Access Compliance Report Public Rights-of-Way (RR Crossings)

Intersection ID: 5967	Main Street: N_TRYON_ST	Location: N/A
ADA ID: E5023ACC5F69	Overall Compliance: No	Severity Score: 0.0
Codes/Mitigation Info/Possible Solution		Field Measurements/Component Compliance

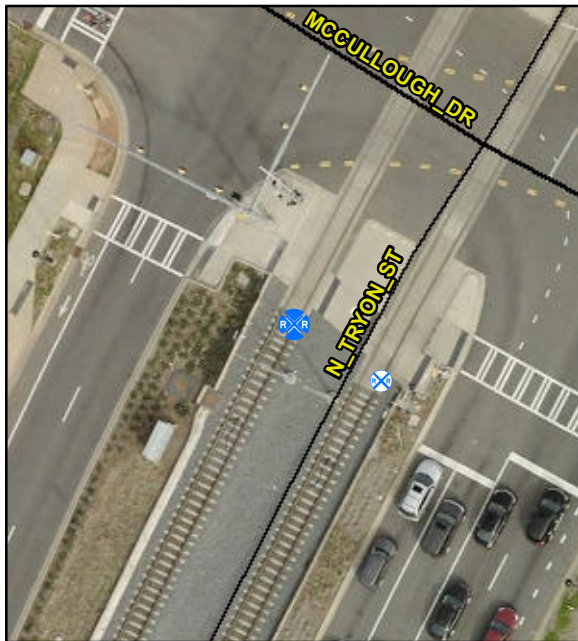
Remove & Replace Detectable Warning System. Provide Pedestrian Gate. Remove & Replace Walking Surface Adjacent to Rail.

R302.7.4, R305.2.5

Compliance	Description	Data
Yes	DWS Provided?	Yes
Yes	DWS Contrast?	Yes
Yes	DWS Width (in)	Yes
Yes	DWS Length (in)	24.0
Yes	DWS Offset (in)	115.0
No	Pedestrian Gate?	No
N/A	DWS Outside Gate?	No
N/A	Rail Type?	LightRail
No	Flangeway Gap (in)	3.0
Yes	Sidewalk Width (in)	113.0
